10/720,173

Eun-Bong Han

LIANG, LEONARD S

Office Action Summary

FIG. 1
(PRIOR ART)

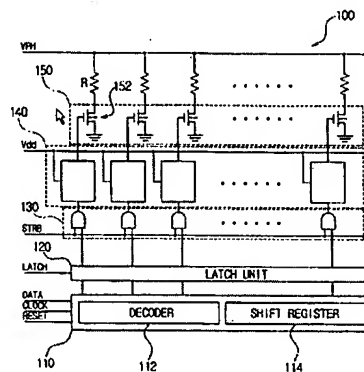
- {claim 1} An inkjet printer head driving apparatus having a plurality of heating elements and nozzles (figure 1, reference 100); a switching unit turning on and off each of the heating elements to heat ink corresponding to selected nozzles to eject the ink (figure 1, reference 150); a level shift unit having a level converter converting a potential level of a signal inputted therein into a predetermined potential level to drive the switching unit (figure 1, reference 140), a buffer to output the converted level of the signal (figure 2, reference 144), and a transient time extending part provided with at least one time extending element to extend by a predetermined time a transient time of the output potential level of the signal during which the potential level of the signal inputted from the level converter to the switching unit is converted from a first signal level to a second signal level and vice versa (figure 1-2, reference 140); a control unit receiving an external

data signal, decoding the received data signal, and outputting the decoded data signal as a nozzle selection signal to the level shift unit to select the selected nozzles corresponding to a to-be-recorded image from the nozzles (figure 1, reference 110)

- {claim 6} A control method of an inkjet printer head driving apparatus having a switching unit driving heating elements corresponding to selected nozzles to eject ink through selected nozzles (figure 1, reference 150); outputting a nozzle selection signal to select nozzles corresponding to a to-be-recorded image out of the plural nozzles; receiving an inputted signal corresponding to the nozzle selection signal and converting a level of the inputted signal to a predetermined

- {claim 8} An inkjet printer head driving apparatus having a plurality of heating elements and nozzles (figure 1, reference 100); a control unit generating a control nozzle selection signal to select a heating element and a nozzle corresponding to an image to be printed (figure 1, reference 110); a level shift unit generating a first nozzle selection signal having a first transient time, during which a level of the first nozzle selection signal is changed between first and second levels, in response to the control nozzle selection signal, and generating a second nozzle selection signal having a second transient time extended by a period from the first transient time of the first nozzle selection signal (figure 1-2, reference 140); and a switching unit turning on and off the heating element according to the second nozzle selection signal (figure 1, reference 150)

- {claim 31} An inkjet head driving unit (figure 1); a control unit to generate a nozzle selection signal to select a nozzle having a heating element (figure 1, reference 110); a level shift unit to convert the nozzle selection signal to have a predetermined level to drive the heating element between a logic high and a logic low and having a buffer to output the converted nozzle selection signal (figure 2, reference 144), and one or more logic units to increase a time required to change the output nozzle selection signal between the logic high and the logic low (figure 1-2, reference 140); and a switching unit to turn the heating element on and off according to the output of the level shift unit (figure 1, reference 150)

- {claim 10} wherein the switching unit comprises a transistor having a first terminal coupled to the level shift unit, a second terminal coupled to the heating element, and a third terminal connected to a potential, and the residual voltage of the switching unit is a voltage of the first terminal (figure 1, reference 150)
